Blackburn Creek
Community Development District

Marked Plan Set Documents of Inspected Curb Inlets and Manholes - Phase 3

APPENDIX A – MARKED PLAN SETS DOCUMENTS FOR MAINTENANCE WORK

Marked Plan Set Documents for Maintenance Work

SHEET NUMBER
B-4A

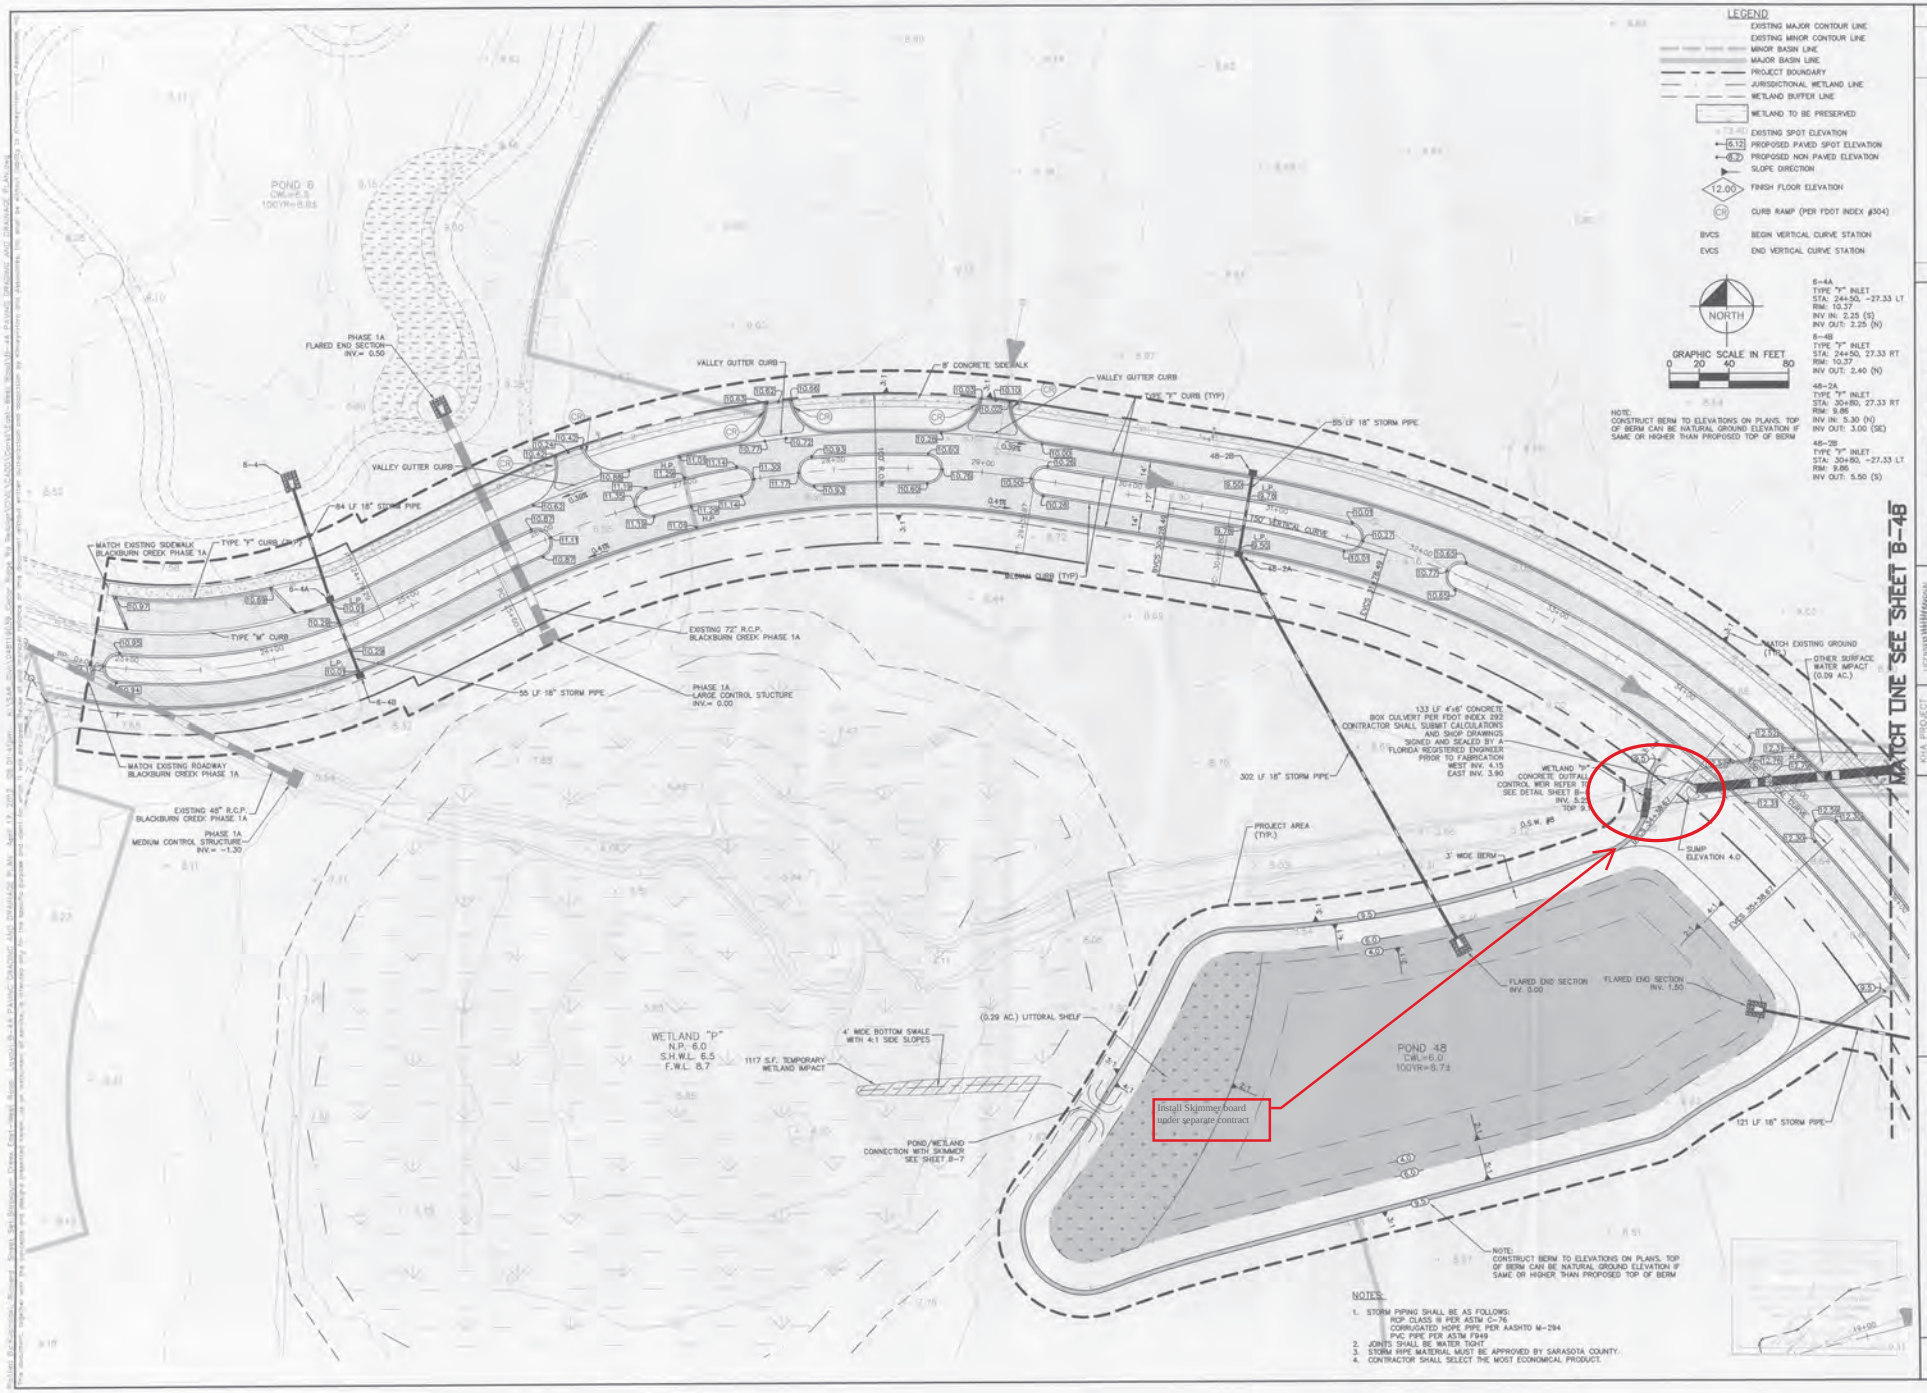
Remove fallen trees and debris from this area

SHEET NUMBER B-4B

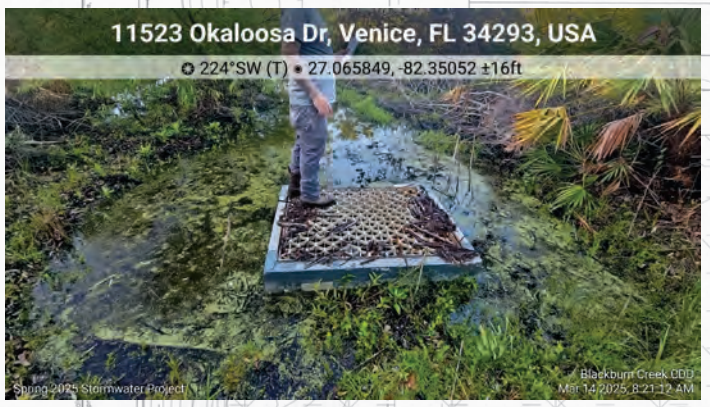
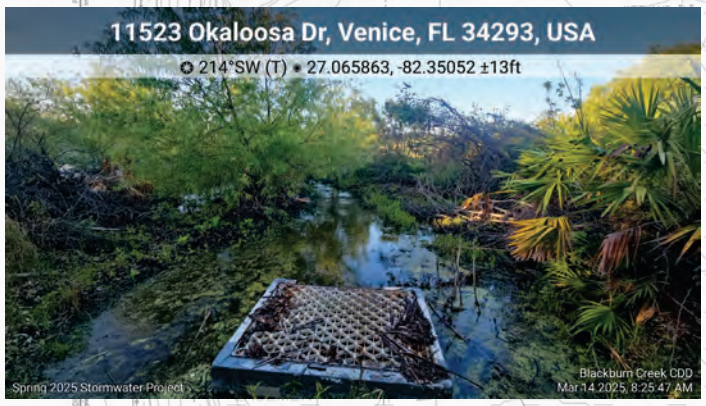
Clear out debris and vegetation from around CS; remove willow and other invasive around conveyance swale and CS

SHEET NUMBER
B-4B

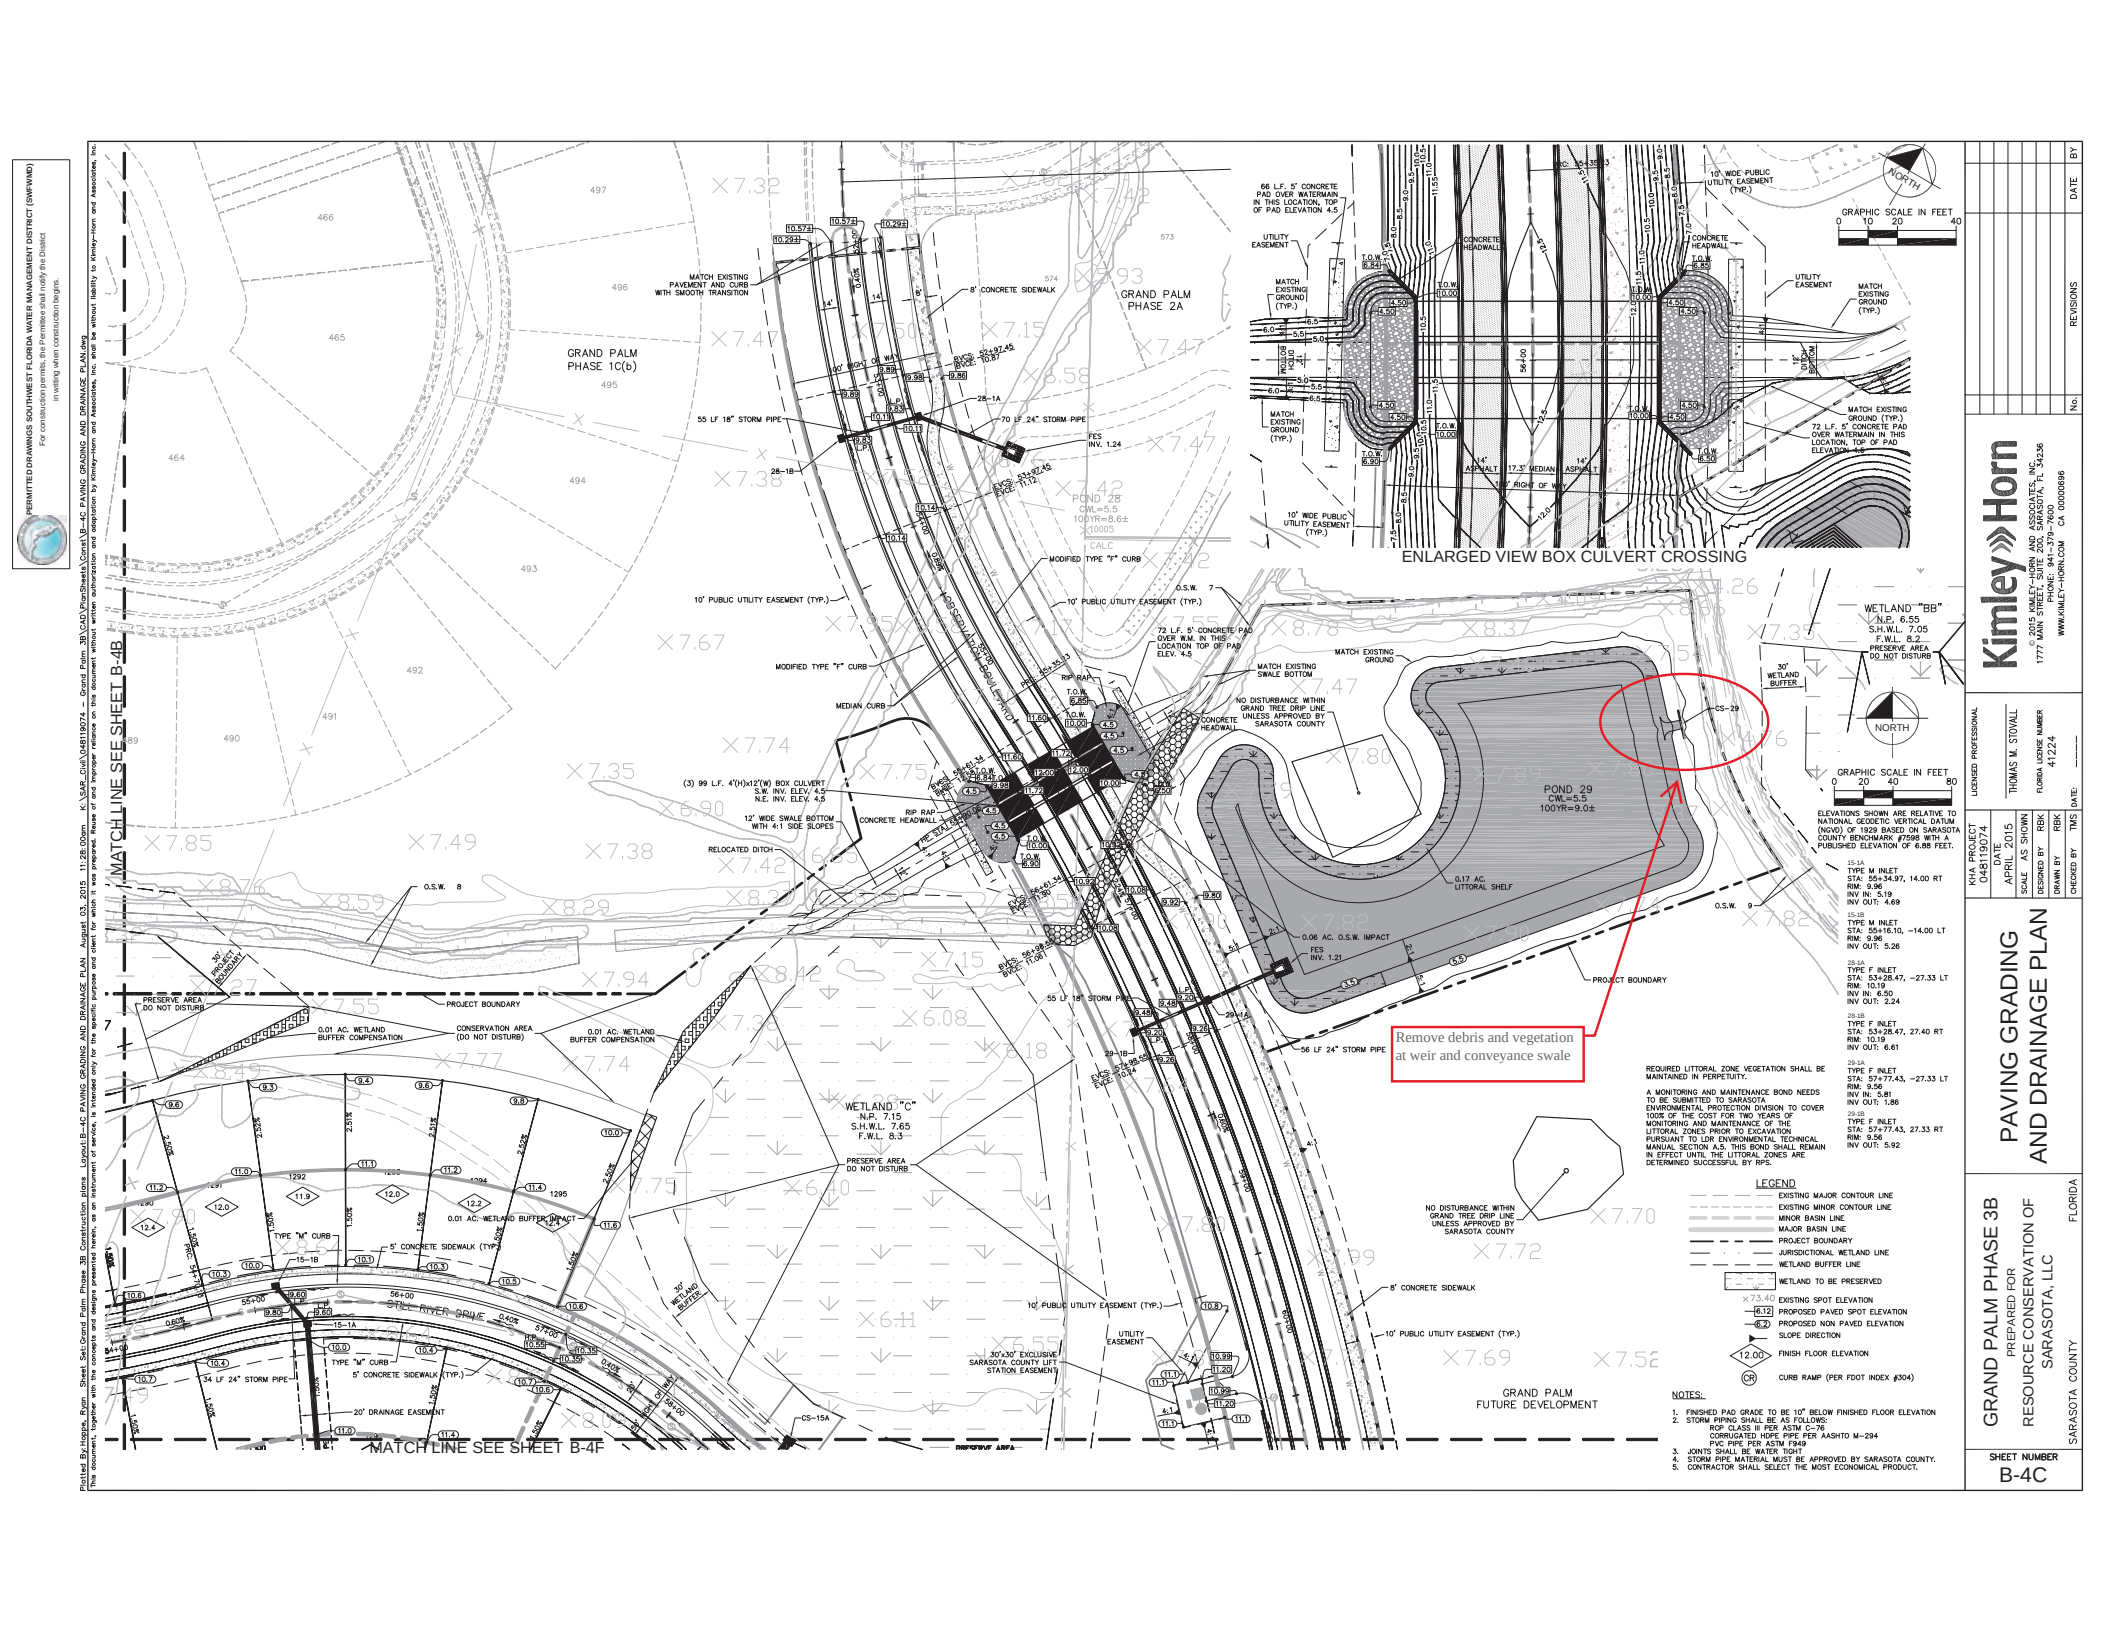
Clear debris and vegetation from structure and conveyance swale about 100ft into wetland; native vegetation to remain, remove invasive and nusiance

Remove nuisance and invasive vegetation and debris from structure and conveyance swale into wetland; about 100ft

Cut down vegetation and remove invasive and nusciance around structure and conveyance swale; remove sediment build up in swale and around structure

SHEET NUMBER
B-4B

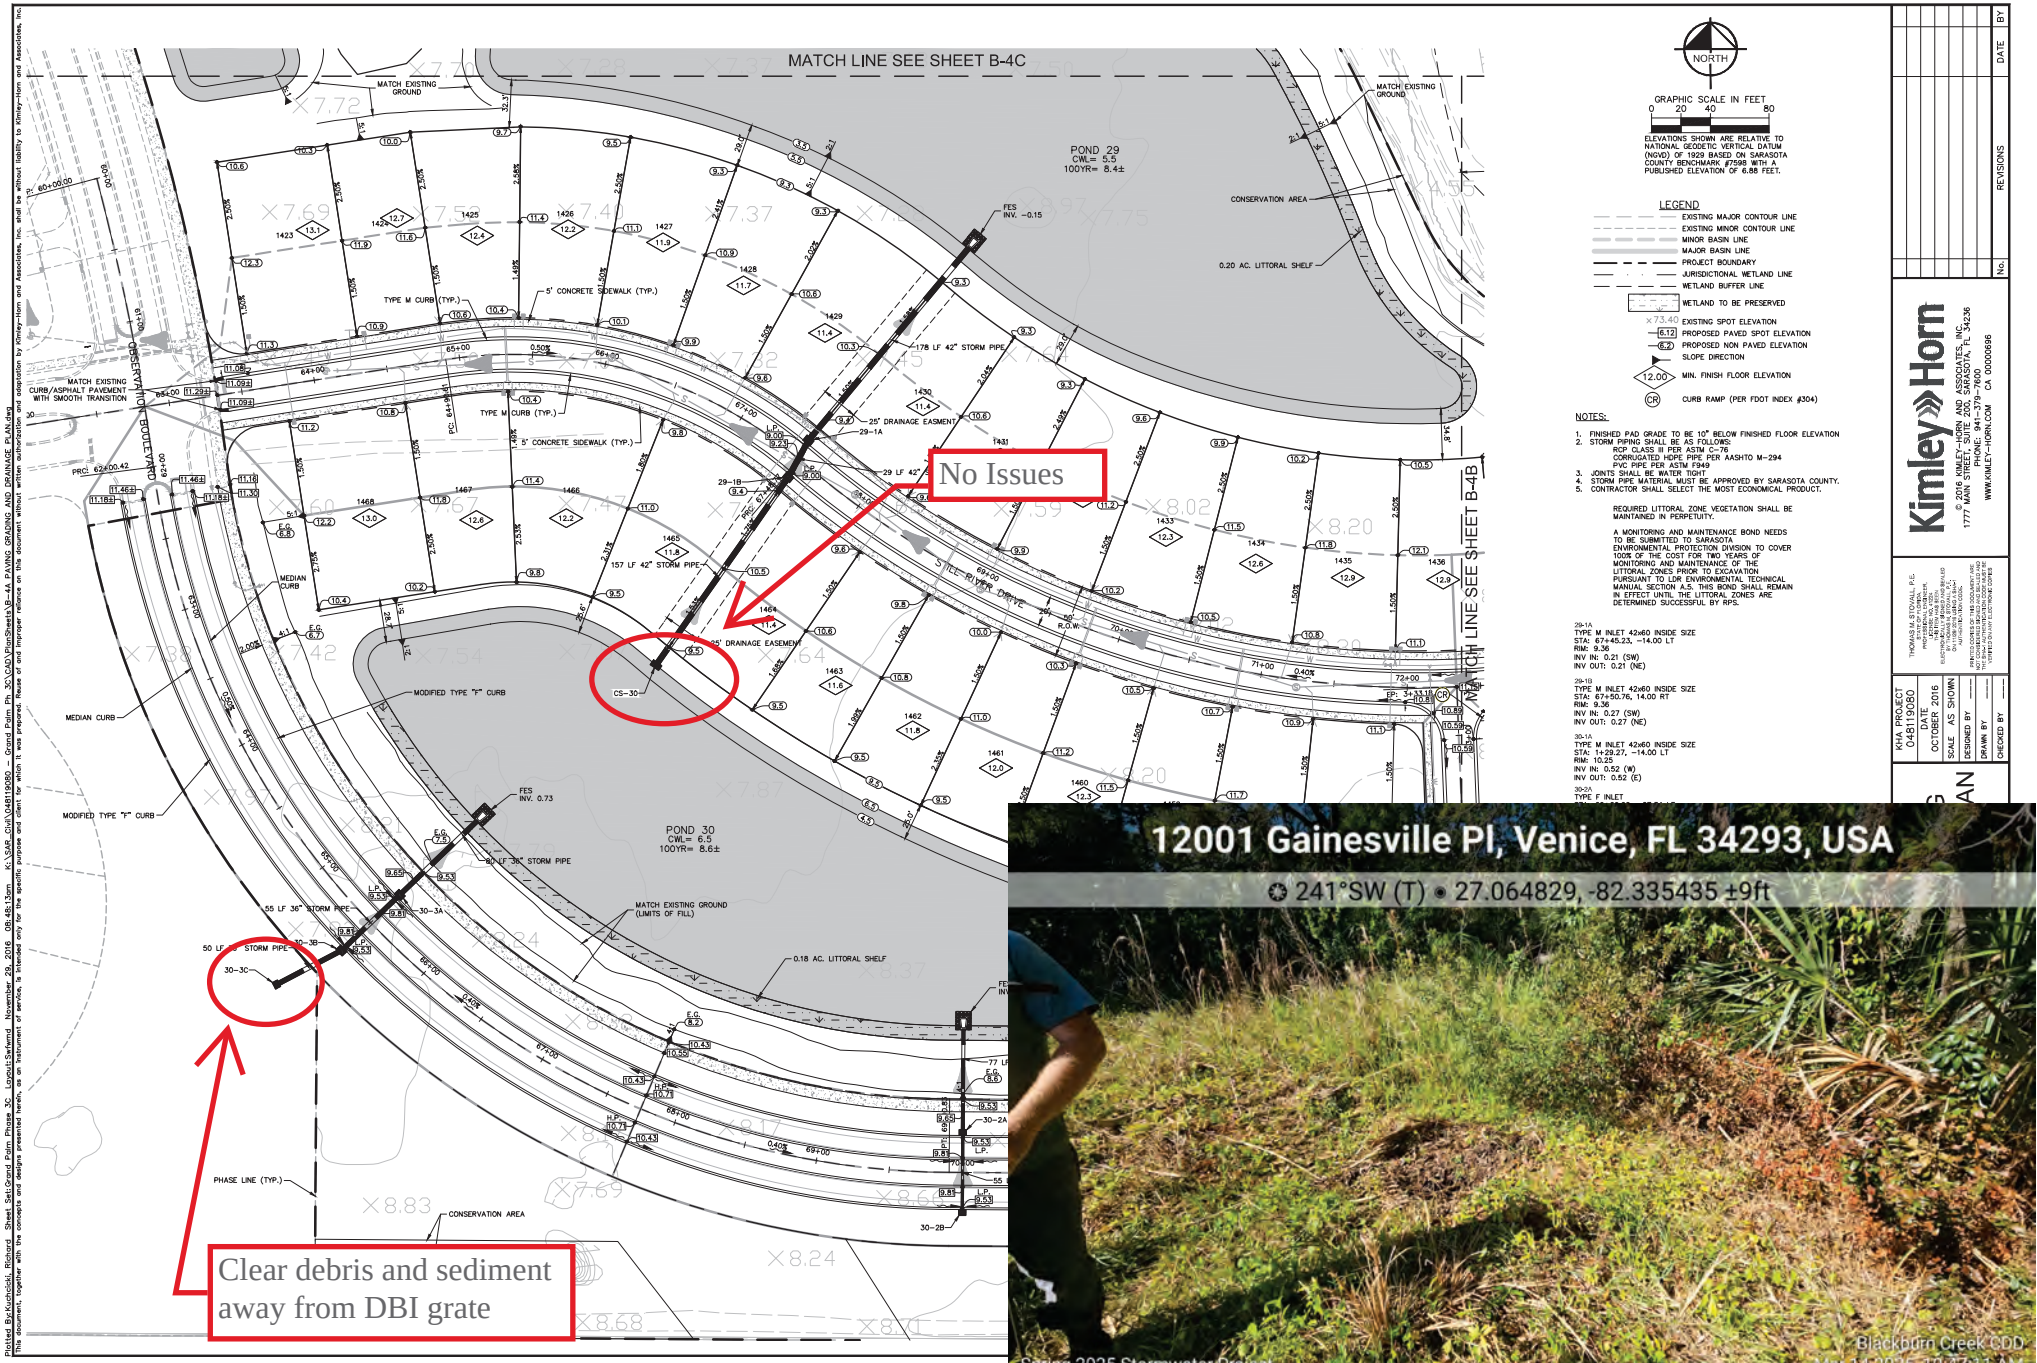
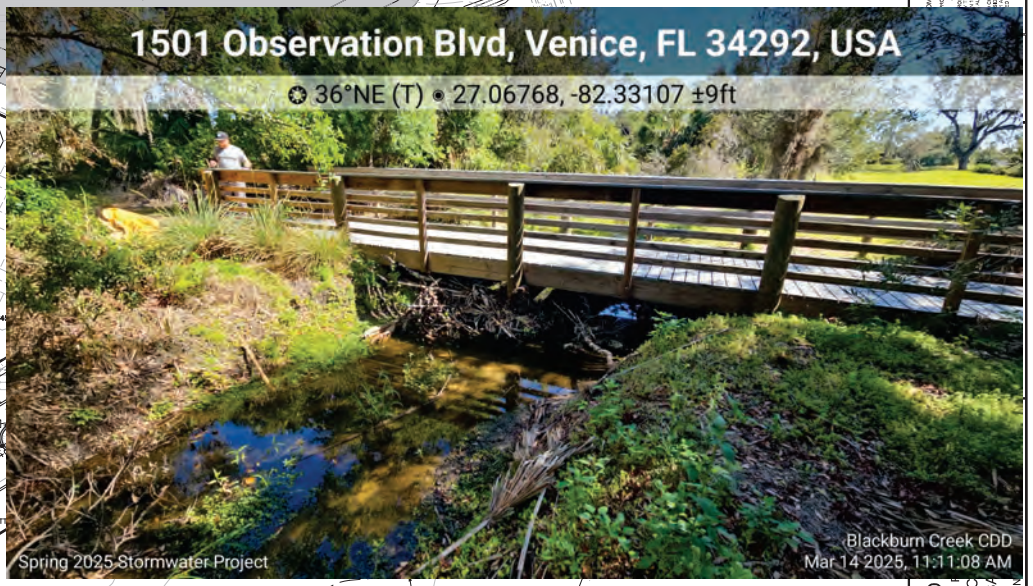
Clear debris in conveyance swale; clear debris from under bridge
